<u> </u>	Application No.	Applicant(s)
Notice of Allowability	10/043,603	BRIAR ET AL.
	Examiner	Art Unit
	 Ishwar (I. B.) Patel	2827
The MAILING DATE of this communication appears on the cover sheet with the correspondence address All claims being allowable, PROSECUTION ON THE MERITS IS (OR REMAINS) CLOSED in this application. If not included herewith (or previously mailed), a Notice of Allowance (PTOL-85) or other appropriate communication will be mailed in due course. THIS NOTICE OF ALLOWABILITY IS NOT A GRANT OF PATENT RIGHTS. This application is subject to withdrawal from issue at the initiative of the Office or upon petition by the applicant. See 37 CFR 1.313 and MPEP 1308. 1. This communication is responsive to amendment filed on January 30, 2003. 2. The allowed claim(s) is/are 1-21.

EXAMINER'S AMENDMENT

FIG. 7

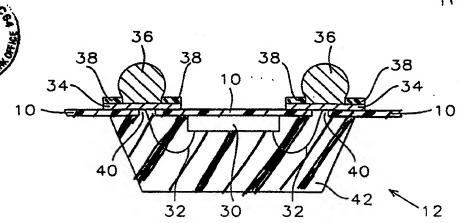
Cross hatching patterns added to elements 38 and 39 of figures 7 and 8 respectively as marked red in the attached drawing sheets.
